**NOTICE TO PROPOSERS****ADDENDUM NO. 02****April 17, 2020****Project: Albuquerque Public Schools DATA Charter High School Reroof**

1011 Lamberton Pl NE  
 Albuquerque NM 87107

This Addendum forms a part of the Contract Documents and modifies the 100% Construction Documents dated **April 6, 2020** noted below. The following changes, additions, and deletions shall be made. All other conditions shall remain the same. Receipt of this Addendum shall be acknowledged. Failure to do so may subject the Bidder to disqualification. This Addendum consists of **6** summary pages, **0** Pre Bid Sign in Sheet, **0** pages of Specifications, **0** pages of Revision Sketches, **1** RFP bid form, and **1** full size Drawings.

A1 NEW ROOF PLAN  
1/16" = 1'-0"

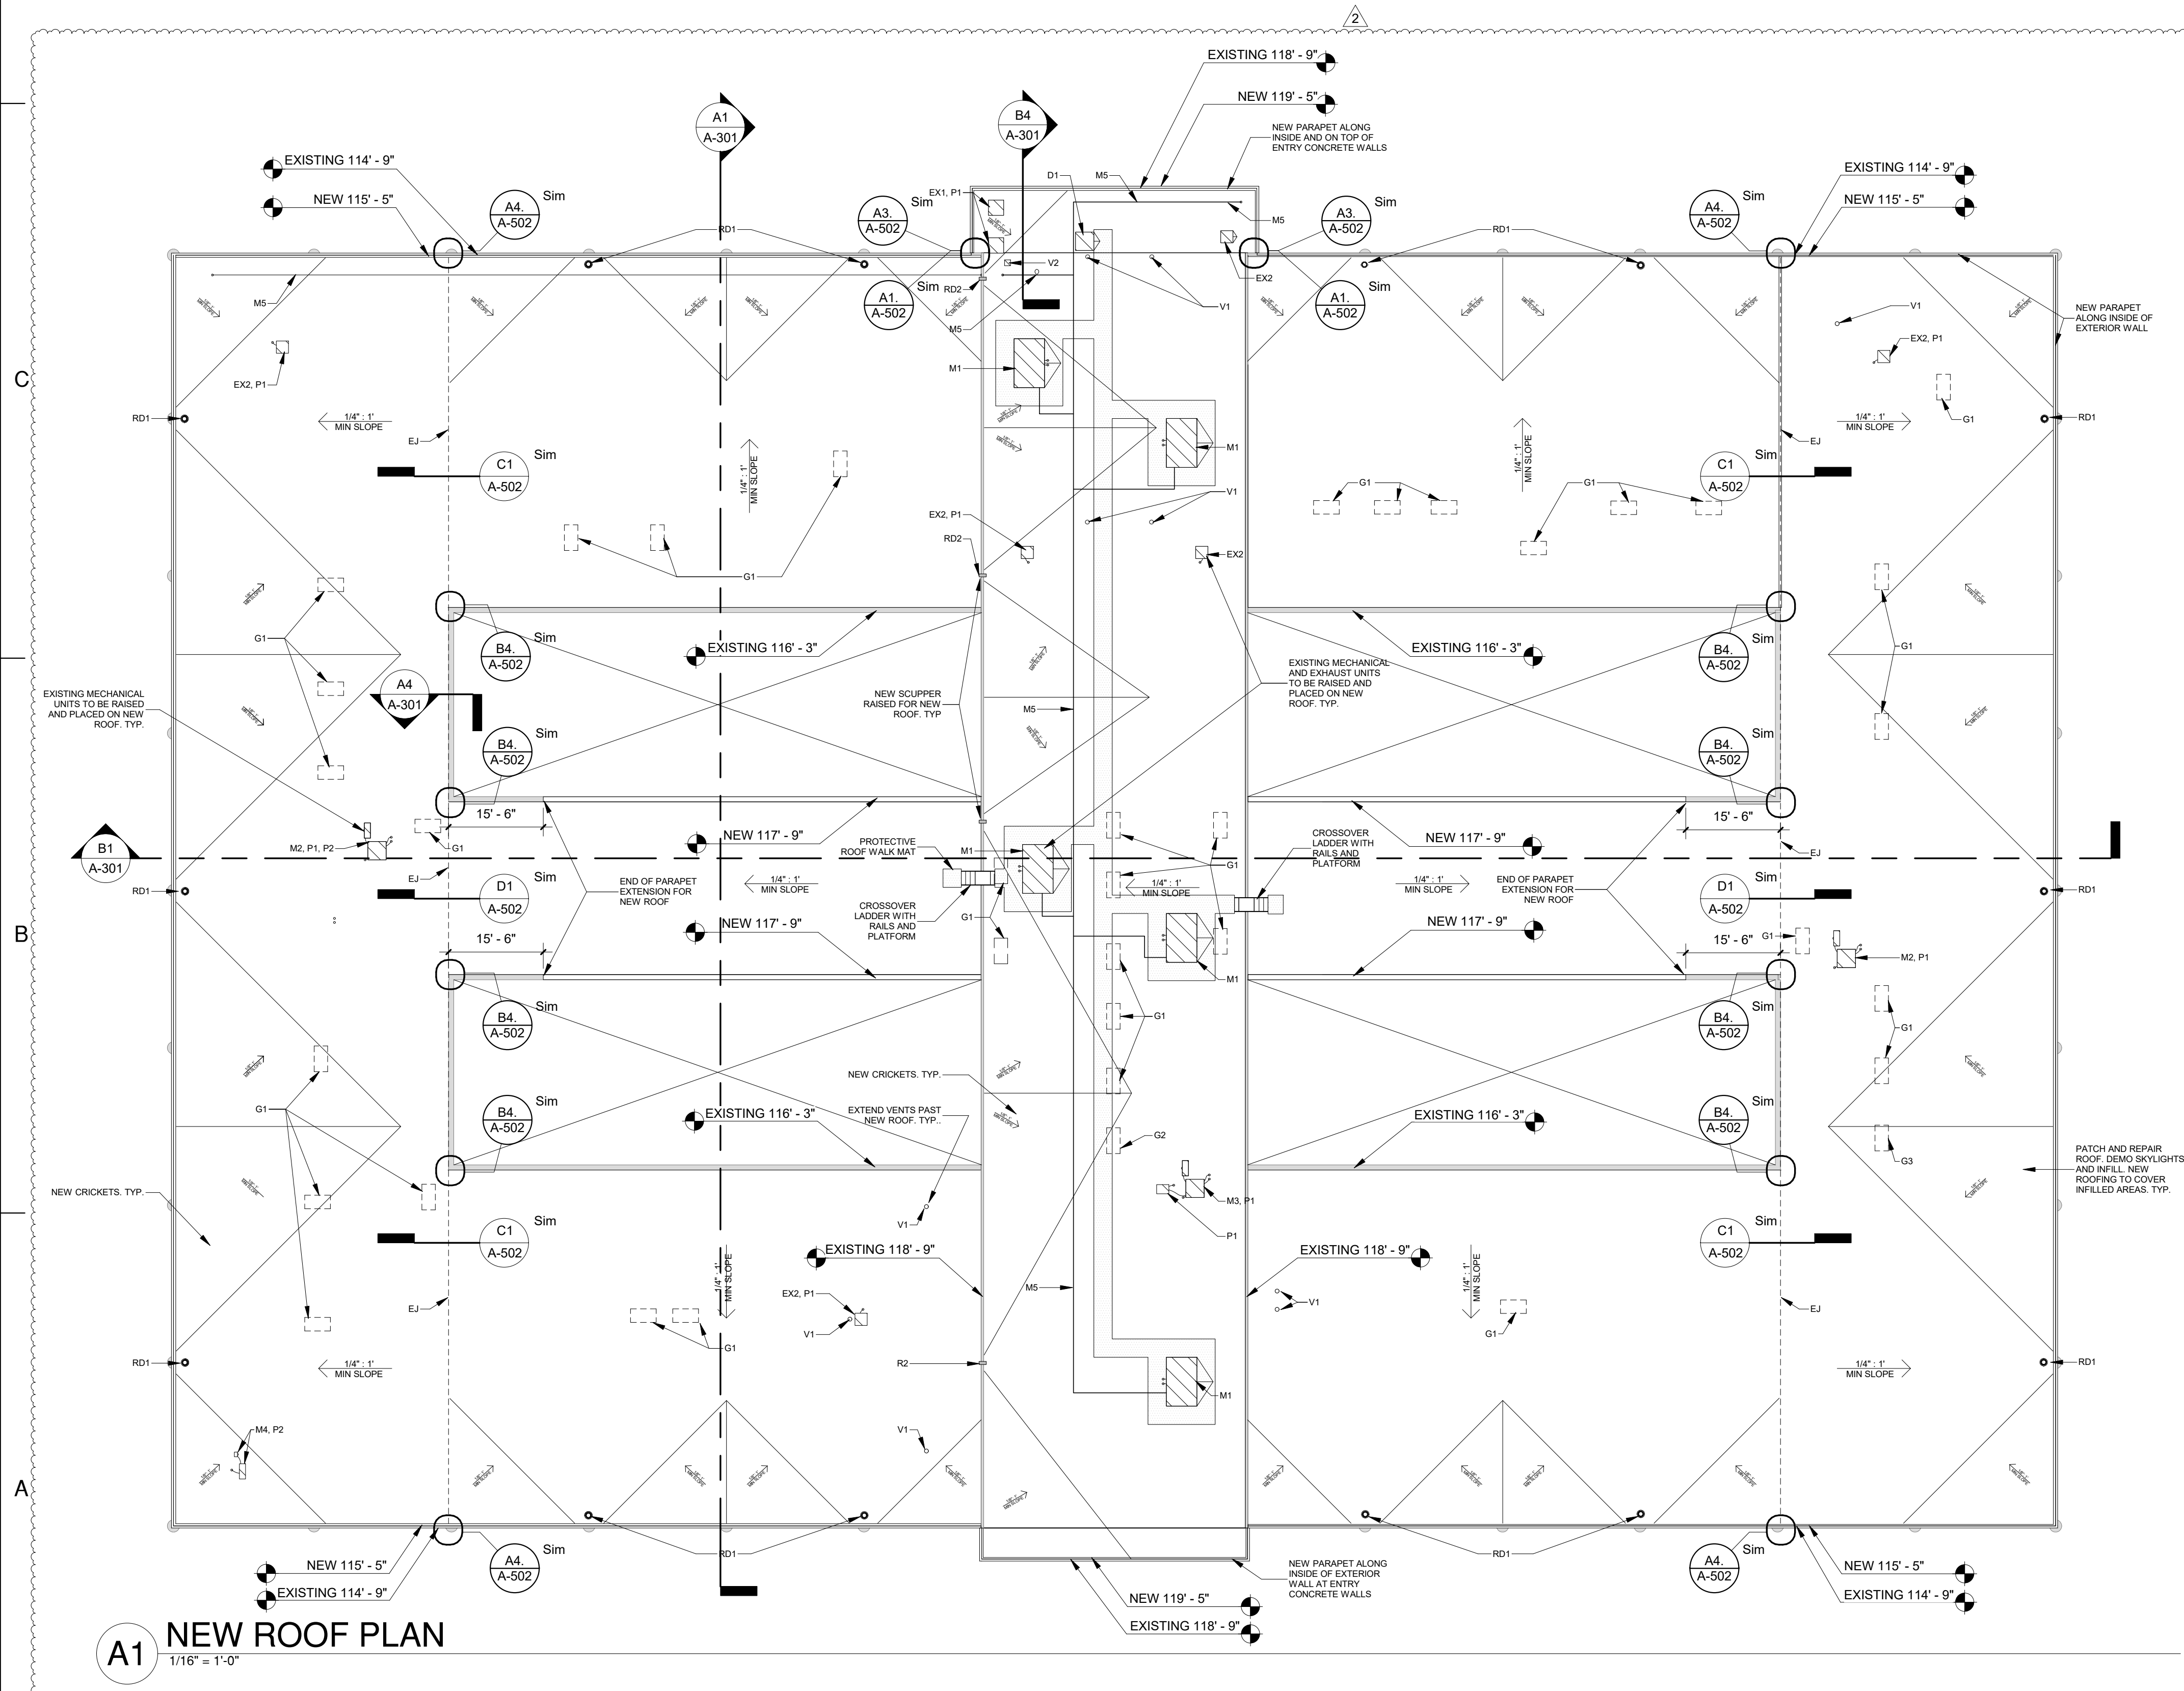
5. **Question:** What are the existing parapet heights?

12. **Question:** At location of roof core the decking was covered with surface rust, are we to address the surface rust on deck? If so what is your procedure for addressing these conditions?

16. **Question:** There are existing wood sleepers under the transformers that are also being used for securing the electrical panel, Does APS want to go back with wood sleepers under the transformers, or should an angle iron stand with round pipe legs be fabricated and installed under transformers?

**Answer: Yes**

**Answer: A cover board, ½” per specification**

**Answer:** See attached for revised roof plan sheet, A-131.

**Answer: All equipment will get new curbs. See new roof plan sheet general notes.**

**Answer: New curbs are required at all units.**

**Answer: See attached for revised roof plan sheet, A-131.**
